Tangy IV Wind Farm Section 36C Variation

Technical Appendix 3.4: Post Scoping Pre-application Consultation

Technical Appendix 3.4 - Post scoping engagement with Argyll & Bute Council

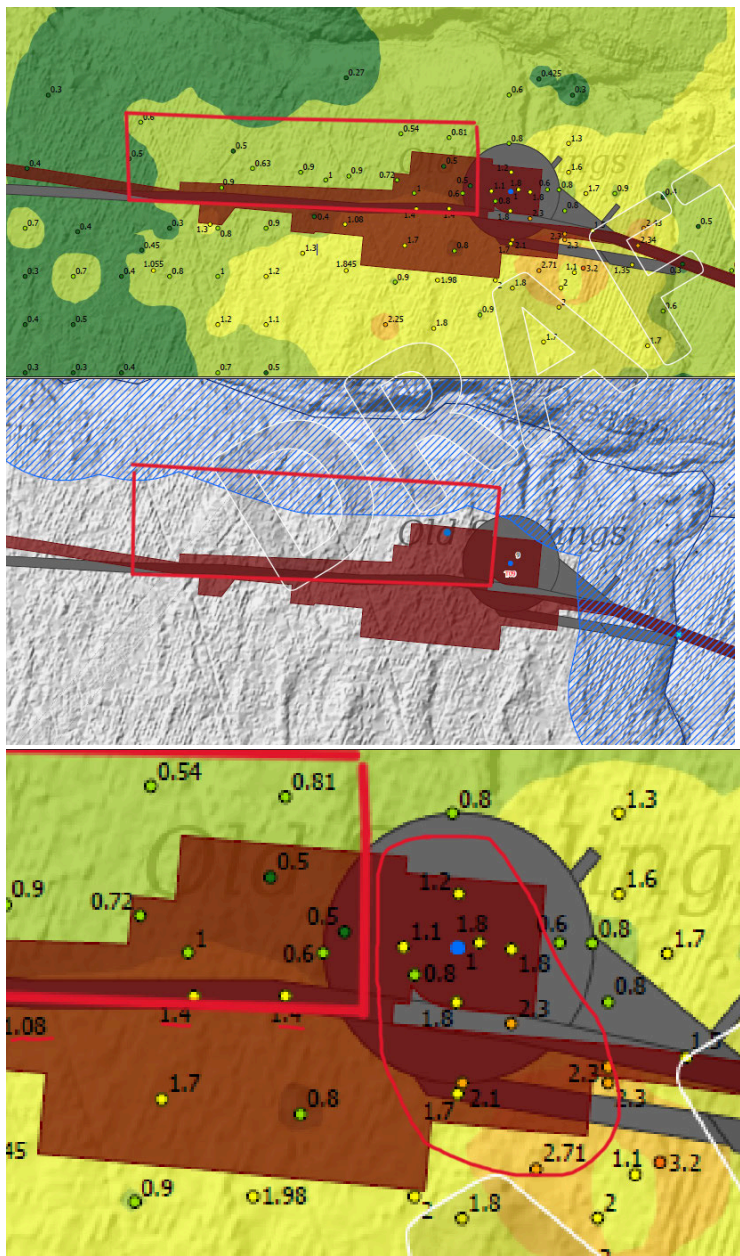
We would also then ask that the access track leading away from the turbine to the east, utilise a floating design to further mitigate impacts on the peat depths over 1m.

Infrastructure	Design rationale for change from consented position
T9	The turbine hardstanding has been rotated by approximately 180 degrees relative to the consented layout to reduce infrastructure encroaching pockets of deeper peat. The infrastructure has been repositioned as far as practicable from these peat deposits while also maintaining the required watercourse buffer to the north. In addition, the turbine infrastructure has been relocated out with a 50 m watercourse buffer to the north and east. Any micro-siting during construction would be restricted in these directions to ensure that the watercourse stand-off distance is maintained throughout construction.

T13

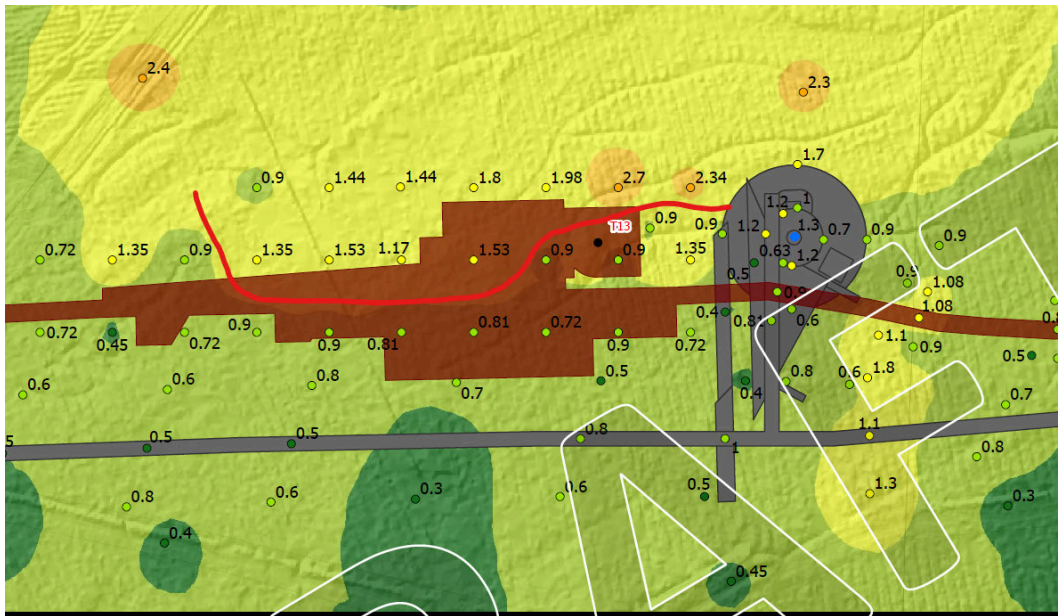
It appears that peat depths over 1m could be easily avoided in this location by slightly shifting the turbine location south by less than 50m. If more detailed peat probing were to be conducted, you could likely find the “edge” of where the peat depths are greater than and the shift may be even less. However, in this position, it appears that it is unnecessary to impact on peat depths over 1m when a large area of peat under 1m is directly adjacent and less than micro-siting distances away. Any shift than north appears to be a better alternative to achieve avoidance in line with NPF4 Policy 5.

The revised T13 arrangement has been designed to avoid deeper peat where feasible, with the turning head positioned within an area of shallower peat to further reduce peatland effects. The proposed hardstanding is larger than that previously consented to accommodate the requirements of the proposed turbine model, and its location is constrained by turbine top-to-top distance and rotor spacing. These constraints meant the consented infrastructure arrangement could not be retained; the hardstanding has therefore been rotated by approximately 90 degrees with the access track realigned accordingly. The layout was iteratively refined to keep peat disturbance broadly in line with the consented position while improving the distribution of disturbance across shallower peat areas.

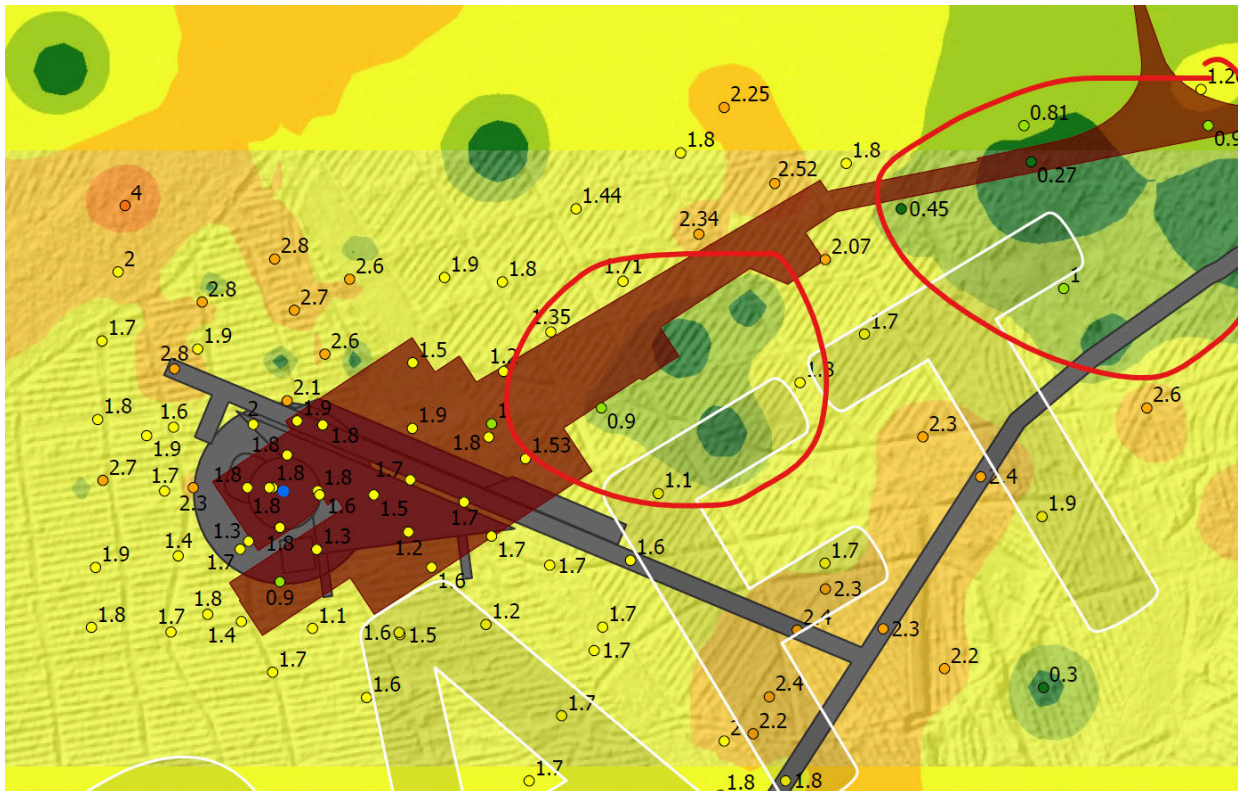
There is a poor amount of peat probing to suggest alternatives. In a situation such as this, where the whole of the area consists of peat depths over 1m, we would expect the peat survey to be used to investigate alternatives. While the interpolated map above shows areas of green in places, these do not appear representative of any or many peat probe locations (especially the small green splotches to north of the turbine location). If the green areas circled above are accurately reflecting peat depths (more data is likely), then the turbine could be shifted east.

The proposed layout removes approximately 500 m of access track previously consented between T14 and the turbines to the south, a significant reduction in linear infrastructure. A turning head at T15 is required to replace the through-route and enable safe vehicle exit.

Retention of the consented turbine location, combined with the increased hardstanding requirements associated with the proposed turbine modification, created potential for additional peat disturbance to the west of the turbine location.

The infrastructure layout was therefore refined through reorientation of the hardstanding and adoption of a non-standard hardstanding arrangement in order to minimise effects on deeper peat deposits as far as practicable. While this solution introduces additional construction and lifting complexity, it substantially reduces the extent of infrastructure requiring construction within deeper peat areas.

T16

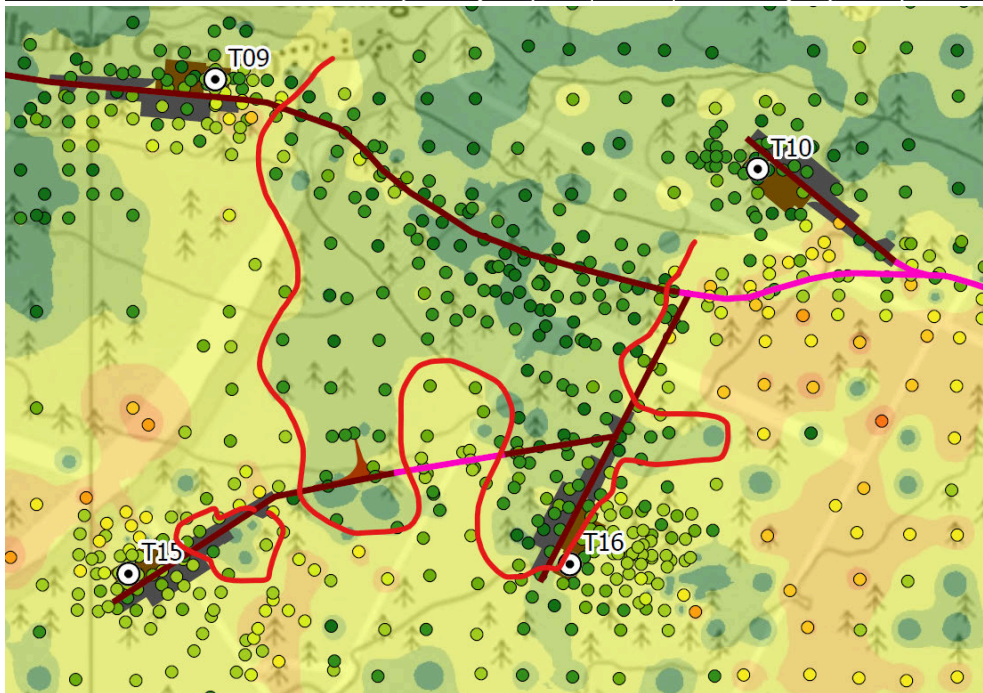
There are large areas below 1m depths that have not been utilised. While we appreciate that there is proximity to T15 that needs to be taken into account, there could be further adjustments to the north. Some minor adjustments could reduce impacts on peat further, we would expect to be further explored.

The proposed hardstanding associated with T16 is larger than that previously consented and, as a result, it was not possible to retain the consented track tie-in arrangement.

The hardstanding has therefore been rotated and the access track realigned accordingly. The revised track alignment has been designed to follow existing landform more closely, rather than traversing directly up gradient, which is anticipated to reduce cut-and-fill requirements, ground disturbance and consequent peat excavation during construction.
